Letter Report No. 243-1

**Review of EPRI/Industry Technical Basis Report
for Resolution of GL 96-06 Waterhammer Issues**

**Prepared for:
U.S. Nuclear Regulatory Commission
Office of Nuclear Reactor Regulation**

**NRC STAFF COMMENTS RELATED TO
EPRI INTERIM REPORT TR-113594,
"RESOLUTION OF GENERIC LETTER 96-06 WATERHAMMER ISSUES"
DATED JULY 1999**

Figure 1. Flow diagram and topics addressed in TBR (items in dotted boxes are not detailed in TBR)

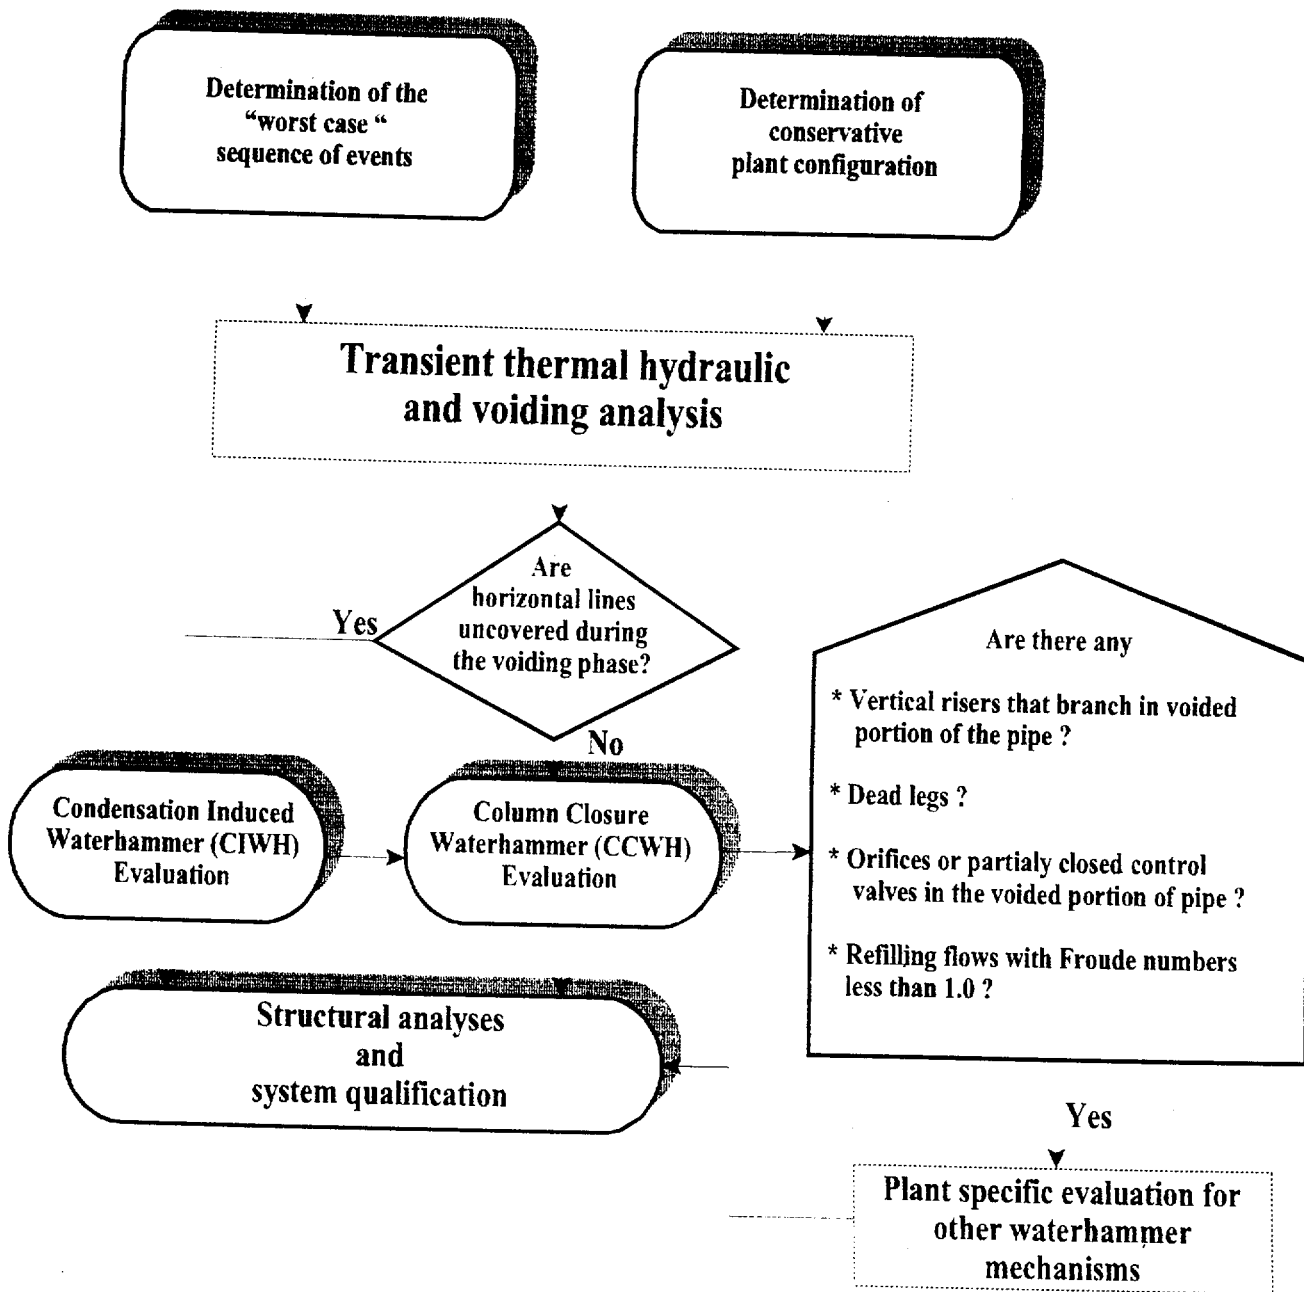
However, the "road map" for an approach to the overall issue, described in Section 1.5 of the interim TBR (see also Figure 1), uses the uncovering of the horizontal lines during the voiding phase as the only criterion for the assessment of the condensation induced waterhammer. Further clarifications on validation and endorsement of the above criteria (suggested in NUREG/CR-6519) by EPRI/Industry approach are needed.

Figure 3. Flow diagram for CCWH evaluation (items in dotted boxes are not detailed in TBR)

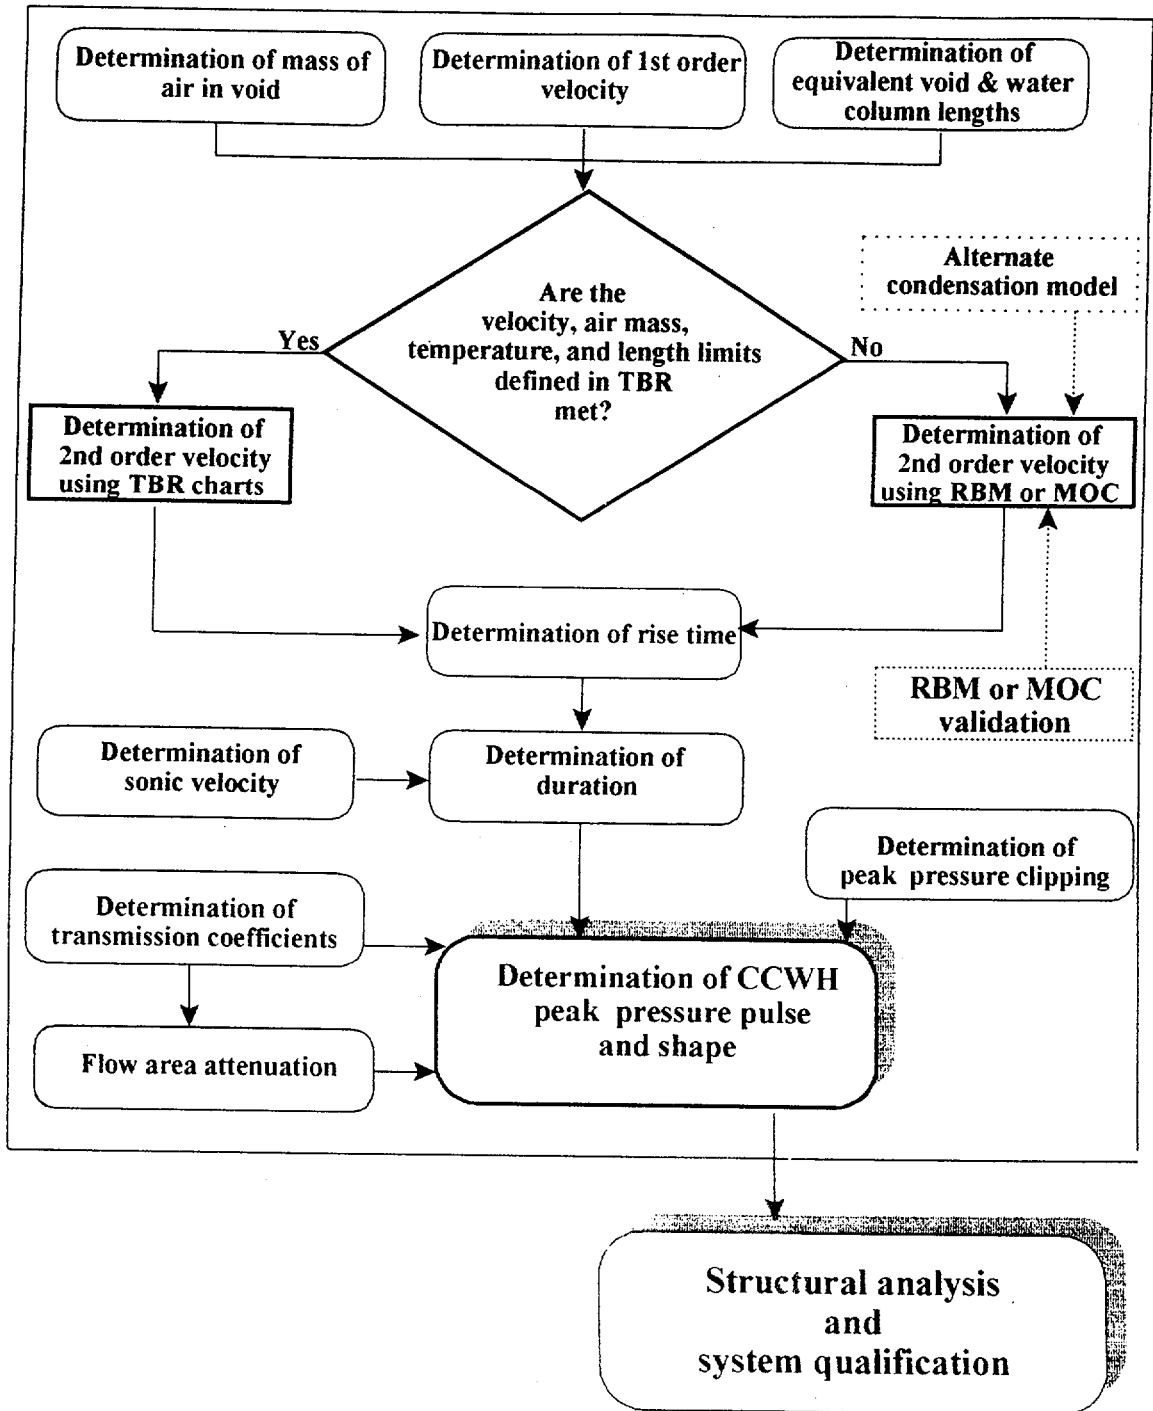
The major components of the suggested utility approach for evaluating the column closure waterhammer are shown in Figure 3 (see also Appendix H of the interim TBR). This evaluation requires many important input parameters (such as void length and location, void temperature, and flow distributions in the system) which are obtained from thermal hydraulic analysis of the voiding phase. However, as discussed earlier in Section 2, the Interim TBR does not provide any guidance for such system thermal hydraulic and voiding analysis to quantify these parameters. It should be noted that the element of "determination of equivalent void & water column lengths", shown in Figure 3, only refers to calculation of equivalent lengths (based on the actual void and water column locations) required for the simplified representation of the system for the proposed evaluation methodology and does not refer to a thermal hydraulic and voiding analysis.
